Dansk Data Elektronik A/S

**Technical
Field Change Notes**

Updated 1st November 1996

BIOC 4000 IES 1 AND 2
COMPONENT SIDE

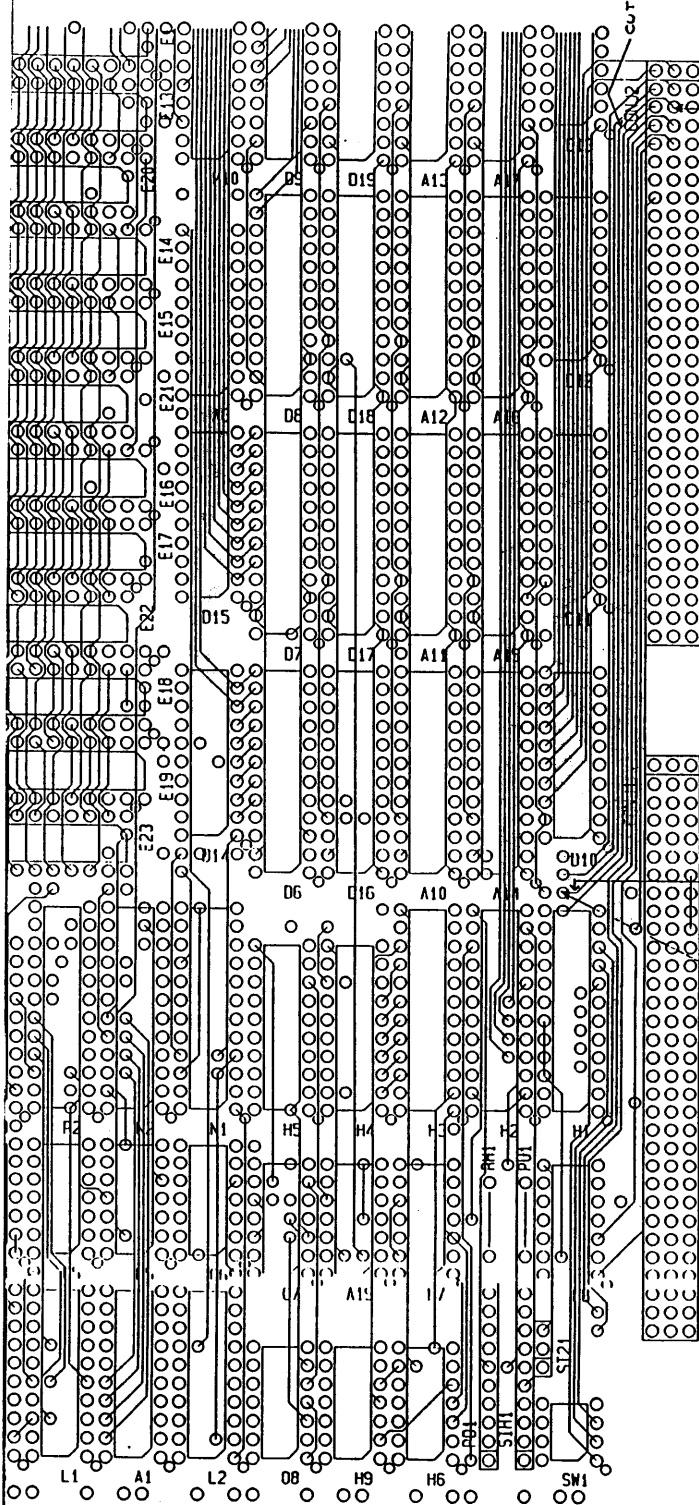
Circuits involved:

Name	Type	Position
CONJ2	Connector	J1

CUT
CONNECT WIRE

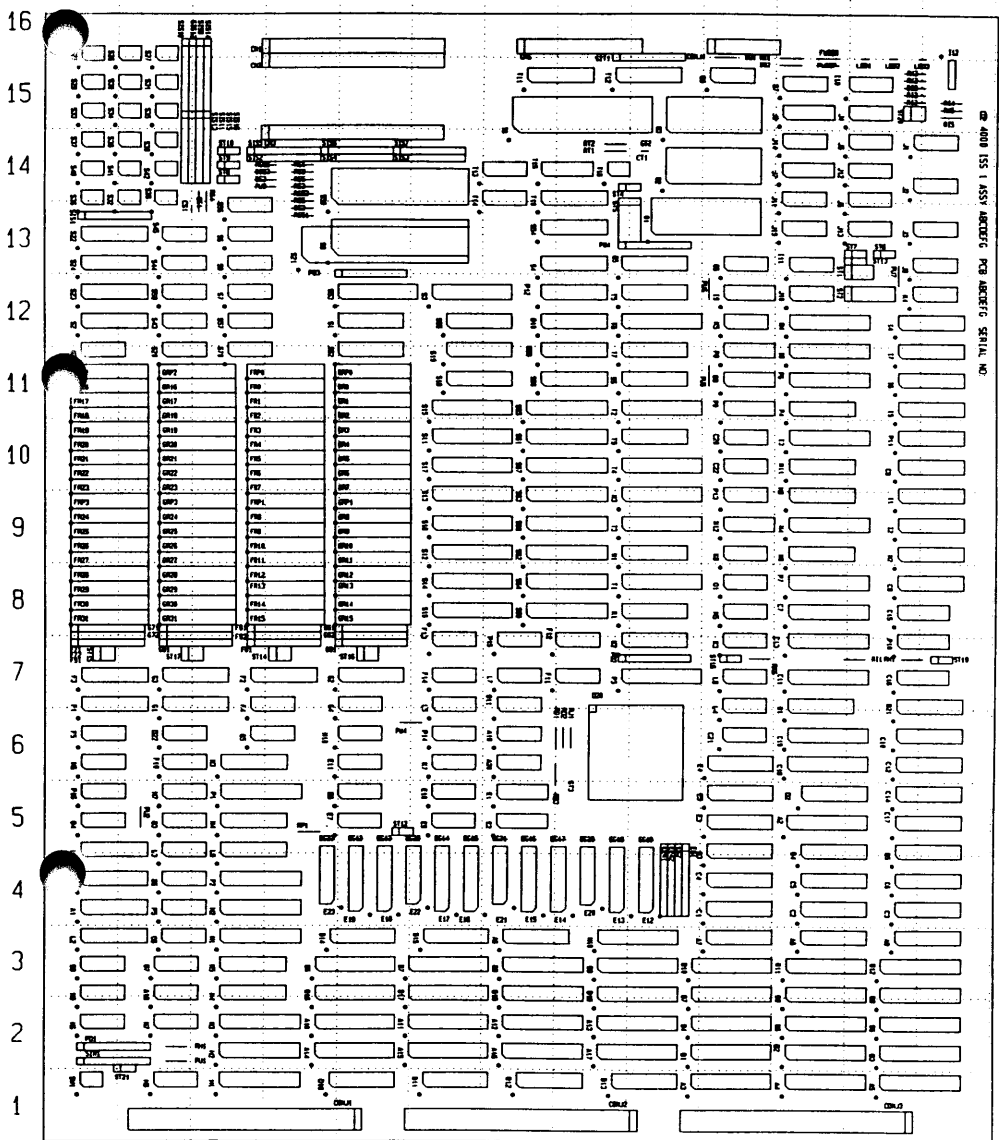
1. Change PAL M1 D3070 to D3070D.
2. Remove wire from PAL L9 D3370 pin 14.
3. Change PAL L9 D3370 to D3380.
4. Connect wire to D3380 pin 14. The wire connects L9 pin 14 to P5 pin 11.

5. Change PAL P2 D3151 to D3152. Insert D3152 with pin 17 out of the socket.
6. Connect P5 pin 1 to P2 pin 17 with a wire on the component side of the PCB.
7. Change component C17 to a 74AS573 device.
8. Change strap ST6. Remove connection between pin 2 and 3. Connect pin 1 and 2.
9. Cut K8 pin 11.
10. Connect O1 pin 1 to K1 pin 13 with insulated wire on the solder side of the PCB.
11. Cut J11 pin 6 near the PCB, bend the component pin, remove the pin in the PCB and clean the solder from the hole.
12. Connect J11 pin 6 to the component hole through a 33 ohm resistor.
13. Cut J11 pin 5 near the PCB and bend the pin.
14. Connect J11 pin 5 to J12 pin 6 with insulated wire on the component side of the PCB.
15. Update PCB revision level to B by removing the letter A in PCB identification field.

Name:	Type:	Position:
M1	PAL D3070	H9
L9	PAL D3370	C4
P5	74F74	B4
P2	PAL D3151	C4
C17	74ALS573	M5

ST6	Strap	M13
K8	74AS32	K9
K1	PAL D3090	H8
O1	74AS21	K8
J11	74AS1004	L13
J12	74AS1004	L14

Board layout details 4600.

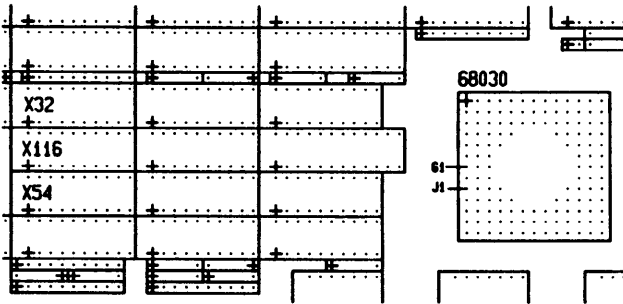
Circuits involved:

Name	Type	Position
X32	PAL	C5
X54	PAL	C5
X116	PAL	C5
X115	PAL	L3
68030	CPU	G6

Solder side PCB layout.

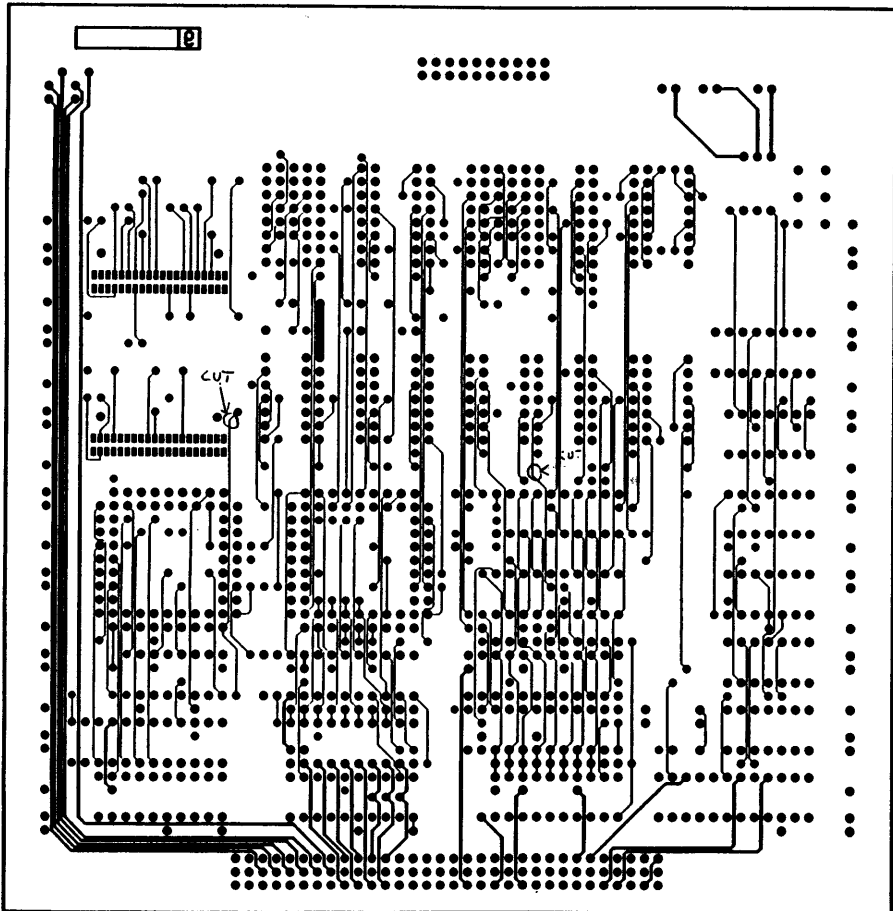
Circuits involved:

Name	Type	Position
IC18	74LS126	F2
IC19	74LS04	A4
IC21	75C188	E5
IC25	75C188	C5

Figure 1.

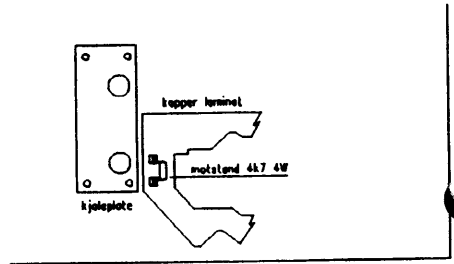
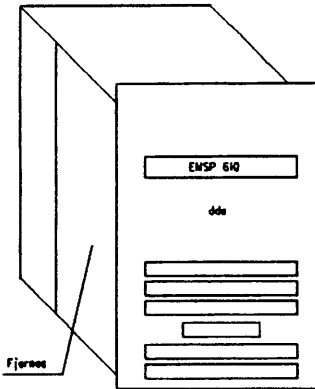
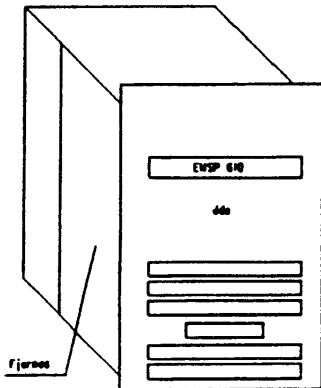
1. Remove the front left heat sink by removing 12 screws.
2. Mount the resistor 4k7 4W in the two empty holes in the PCB. See figure 1 for mounting details.
3. Secure the resistor on the PCB by using some silicone glue.
4. Mount the heat sink again.
5. Update the revision field on the front plate of the power supply from "empty" to B by writing a B in the revision field.

See figure 1.

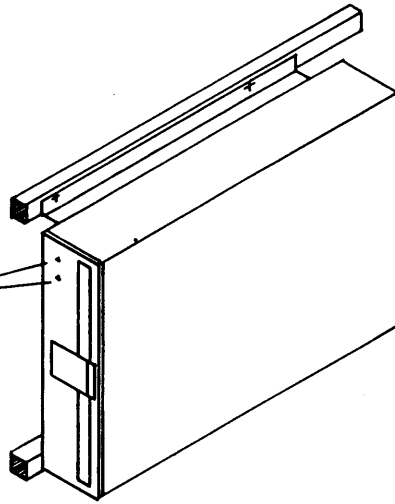
BEFORE CHANGE

AFTER CHANGE

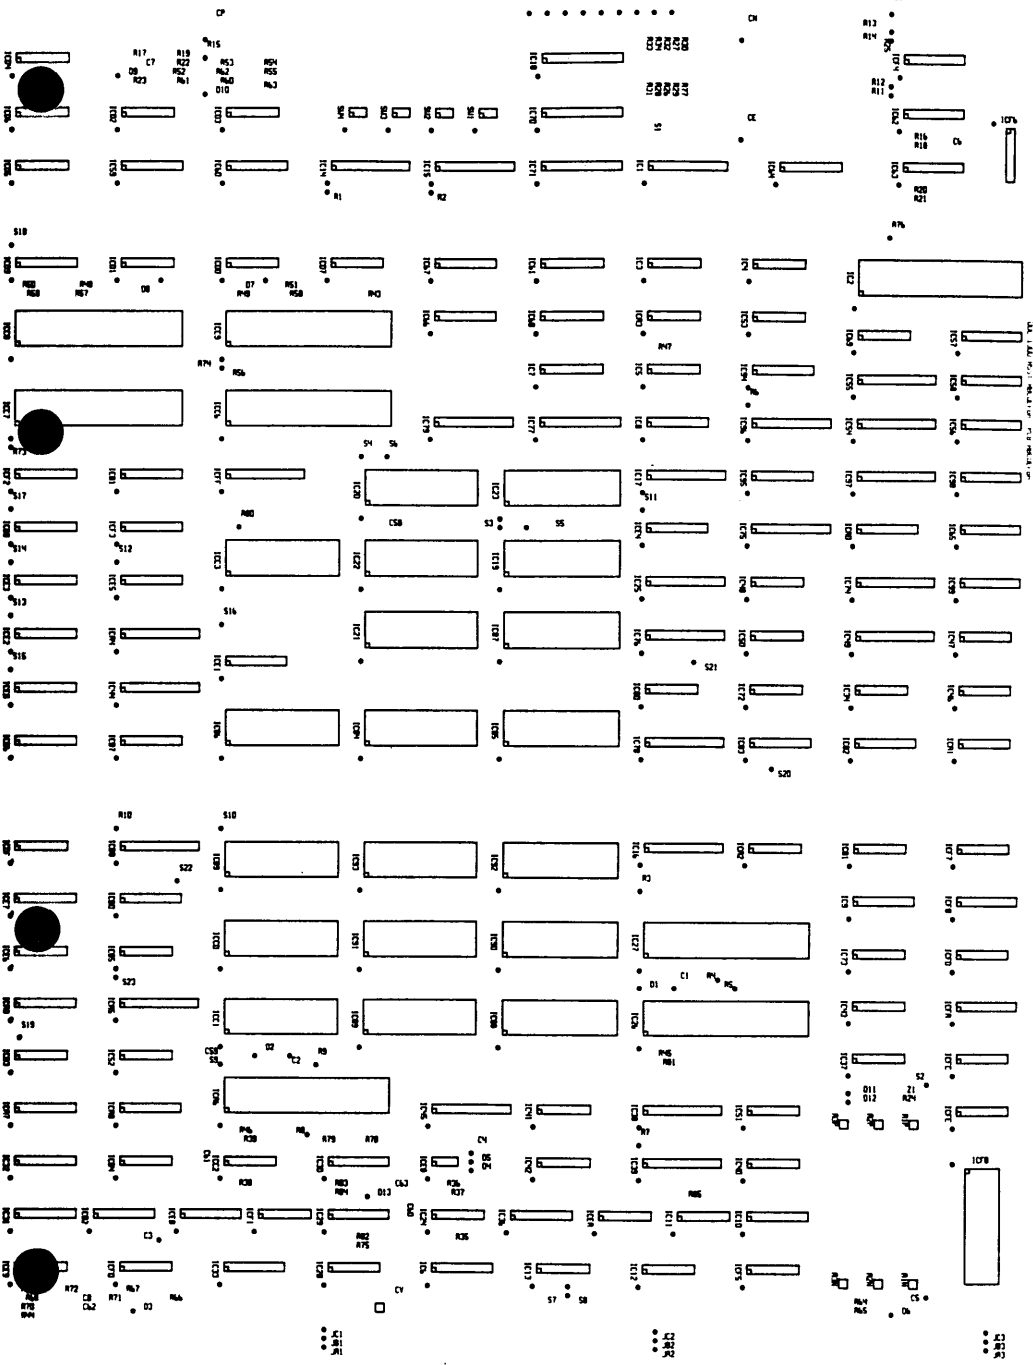
Disconnect IC48 pin 1 from IC2 pin 19 by cutting the wire on PCB layer 1, component side, as indicated.

Add new IC (SN74ALS74AN) on top of IC34 soldering pin 1, 2, 3, 4, 7, 10, 13, and 14 directly to the pins of IC34. Pin 5, 6, and 8 of the new IC remain not connected.

Connect new IC pin 9 to IC48 pin 1 with insulated wire on component side.

On the 2500 ALFA board.

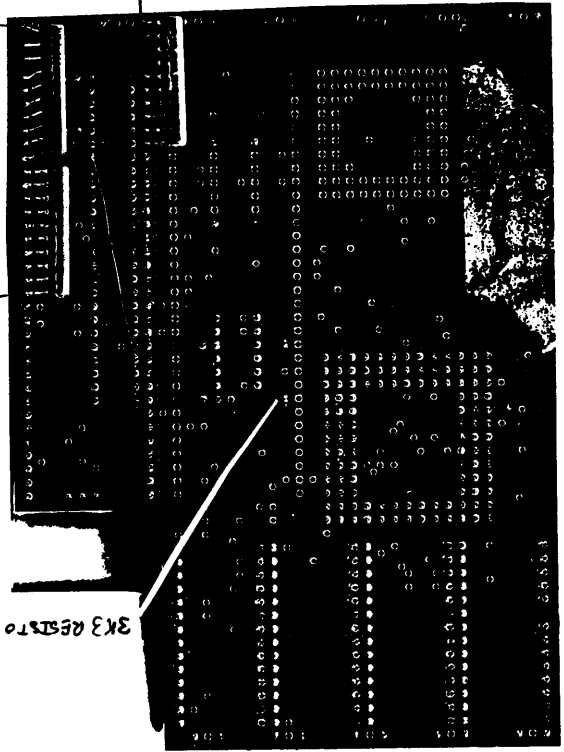
The cdis signal of the 68020 (pin H1) should be pulled up ,
The resistor should be placed alongside the 74S74 in the holes at pin 14 and 10 of the 74S74 (5.08 millimeters from the 74S74).

Short circuit pin 60 and pin 59 of CP10.

Pin 1 of 3K3 to VCC
